City of Tacoma

ADDENDUM NO. 3

Request for Bids Specification No. TR25-0051F

Lincoln Ave and Port of Tacoma Road Railroad Crossings Signal Installation

RAIL-0003S (595)
SHEET NO. CH03
SHEET 114 OF 114

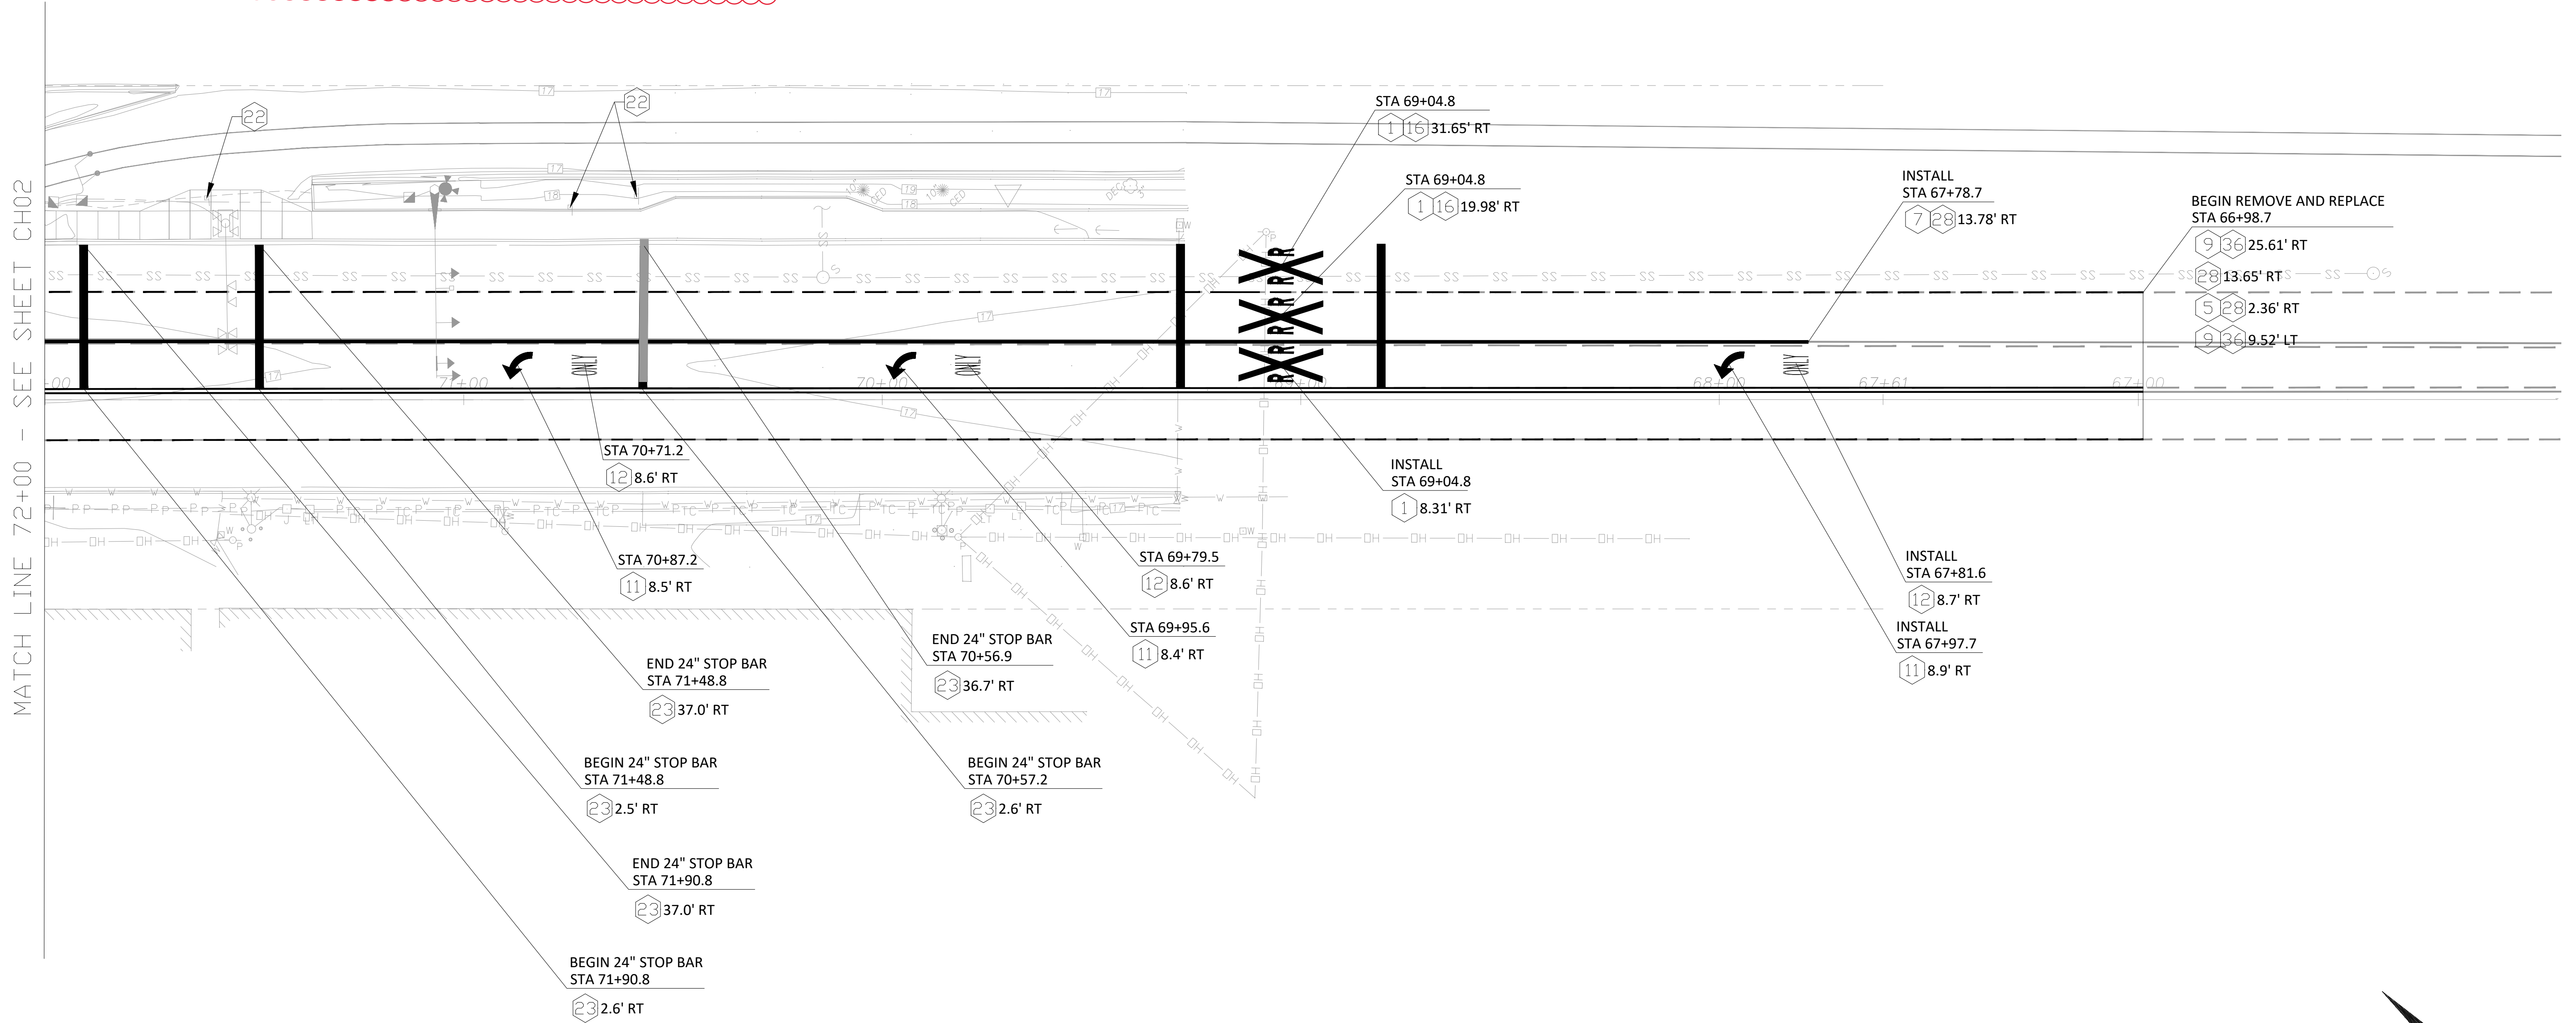
Remove sheet CH03 Channelization and Signage Plan and replace it with CH03 Channelization and Signage Plan noted Addendum No. 3. Construction notes 5 and 9 are revised.

- 5 REFRESH YELLOW DOUBLE LINE, **PAINT**. SEE CITY OF TACOMA STD PLAN CH-03A DOUBLE YELLOW CENTER LINE (4" X 2) DETAIL.
- 6 REFRESH YELLOW DOUBLE LINE, **THERMOPLASTIC**. SEE CITY OF TACOMA STD PLAN CH-03A DOUBLE YELLOW CENTER LINE (4" X 2) DETAIL.

- 7 INSTALL YELLOW TWO-WAY LEFT-TURN CENTERLINE, THERMOPLASTIC. SEE CITY OF TACOMA STD PLAN CH-03A YELLOW TWO WAY LEFT TURN LINE (4" X 2) DETAIL.
- 9 INSTALL WHITE WIDE SOLID LANE LINE, THERMOPLASTIC. SEE CITY OF TACOMA STD PLAN CH-03A WHITE GORE LINE (8") DETAIL.
